INDESIT company

Model type:
LI680DUO

Commercial code:
F029514

See figure N1045065FIG1.

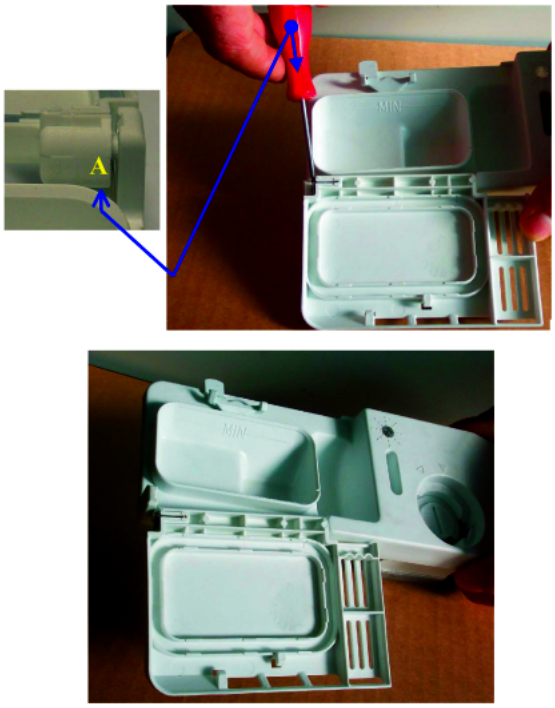
n1045065: Modification of Turbo-Dry Tube/Sump

From serial no. 30705.0001, the Turbo-Dry tube/Trap has been modified on EVO3 dishwashers with Turbo-Dry drying system.
The new tube has a smaller diameter.
The parts affected by this modification are:
TURBO-DRY ASSEMBLY: premodification 094600 new 096408
TURBO-DRY SUMP TRAP ASSEMBLY: premodification 094602 new 096409

TURBO-DRY TUBE/SUMP: premodification 094603 new 096410
The premodification tube will continue to be managed.
The premodification Turbo-Dry assembly and trap will be managed by the warehouse while stocks last, after which the new parts will have to used on premodification appliances as follows:
- TURBO-DRY ASSEMBLY REPLACEMENT: order the new assembly SAT code 096408 and premodification tube SAT code 094603.
- TURBO-DRY SUMP TRAP ASSEMBLY REPLACEMENT: order the new bowl SAT code 096409 and new tube SAT code 096410.

N1045069FIG1

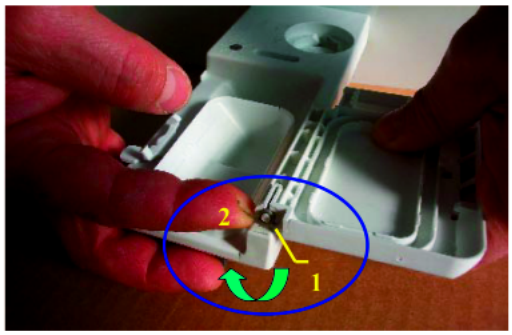
Lid installation instructions:
1) prise the lid out of the dispenser seat using a small screwdriver at point A (figure N1045069FIG1);
2) replace the lid, checking that release spring B (figure N1045069FIG2) is in place; before fitting the new lid load the spring from position 1 to position 2 (figure N1045069FIG2);
3) fit the lid in its special seat and check for correct operation (figure N1045069FIG3).
Lid closing may be harder for the first few cycles after replacement, due to settling of the material.

N1045069FIG4

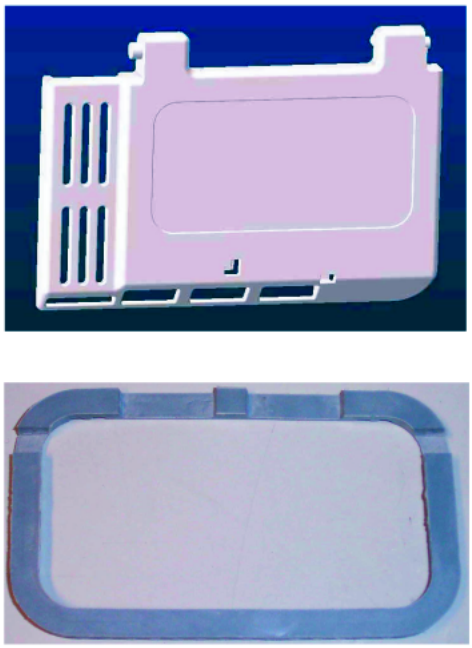
To obtain better dissolving of the detergent during the wash cycle, the following modifications have been made to EVO3 dishwashers:
- new dispenser lid, replacement code 098134 (see figure N1045069FIG4) created;

N1045069FIG5

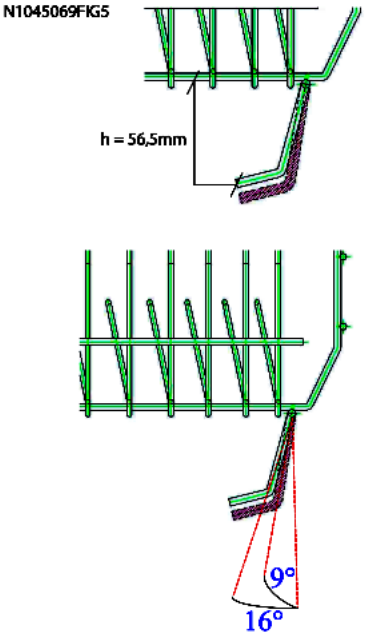
- upper racks modified with lid catch angle changed from 9° to 16° (see figure N1045069FIG5);
- MultiSystem lower racks modified with insertion of a spacer wire at the electric dispenser (see figure N1045069FIG6).

N1045075FIG1

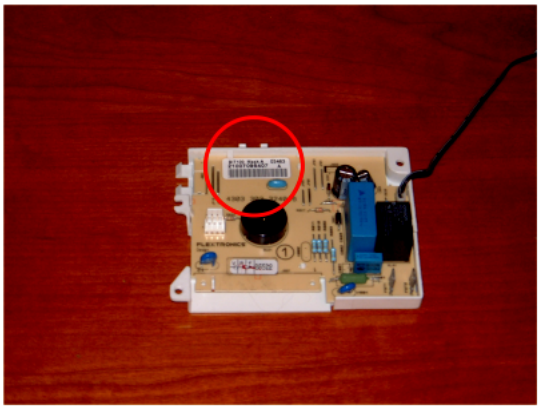
The card code is printed on an adhesive label located on the box or on the card itself (illustration N1045075FIG1).

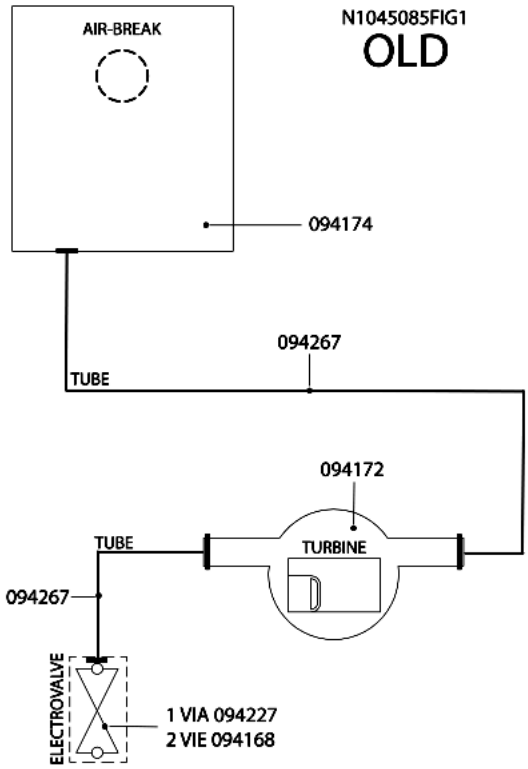
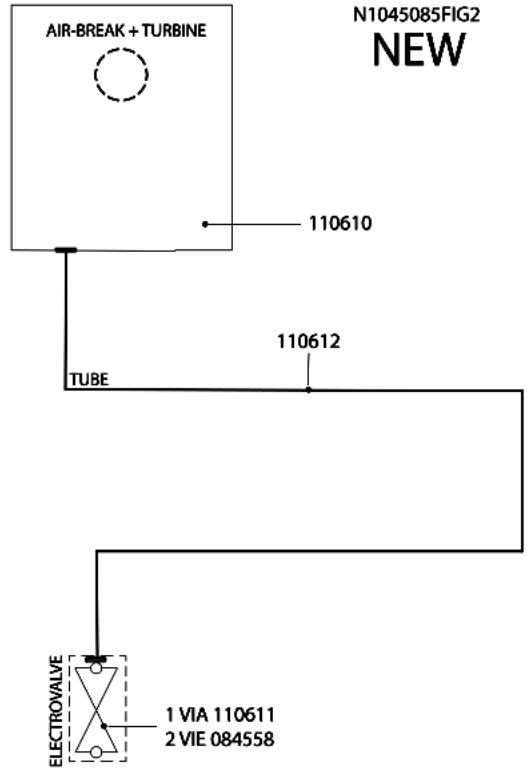
All dishwashers affected by this note have been equipped with a new litre counter turbine on the air-break.
Picture N1045085FIG1 illustrates the premodification structure, picture N1045085FIG2 the new structure.

AIR-BREAK:
new 110610;
premodification 094174;
the new item features a new integrated litre counter turbine and its water supply hose has a smaller diameter.

SOLENOID VALVES:
new:
1-WAY code 110611;
2-WAY code 084558(Rohs 143737);
premodification:
1-WAY code 094227;
2-WAY code 094168;
the new solenoid valves have a smaller diameter drain hose fitting.

HOSES:
new solenoid valve hose/air-break code 110612;
premodification turbine hose/air-break code 094267;
premodification solenoid valve hose/air-break code 094267;
the new hose has a smaller internal diameter.

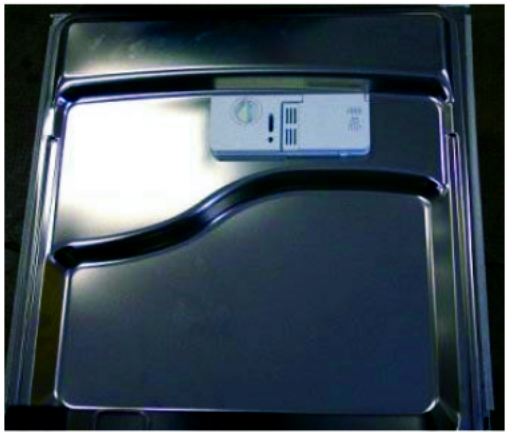
The position of the electric distributor has been changed as shown in the attached illustration.
The new machines have a new industrial code.

Introduced items:
C00118140 upper rack
C00109698 inside door

Premodification items:
C00114486 upper rack
C00095276 inside door

N1045136FIG1

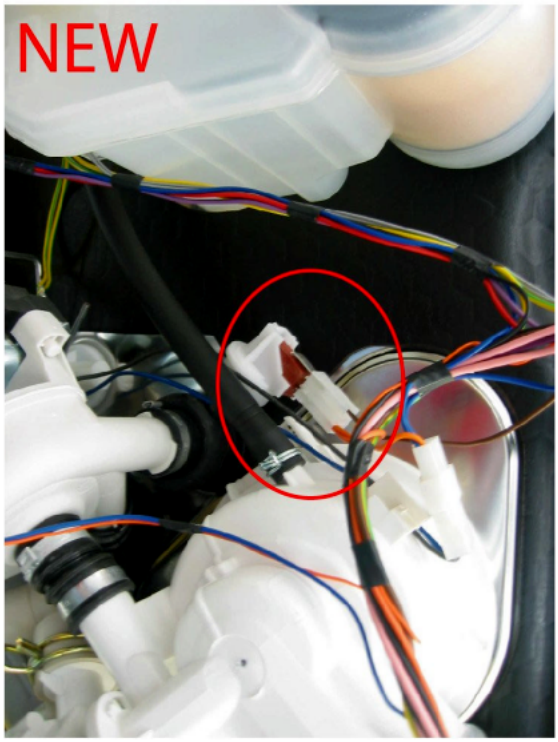
In modified products the connector going to the high pressure sensor is part of the wiring assembly (see picture N1045136FIG1). In premodification products the high pressure sensor is connected to the wiring assembly by a cable that is part of code C00094157 (see pictures N1045136FIG2-3).

The new parts are not individually interchangeable with premodification ones.
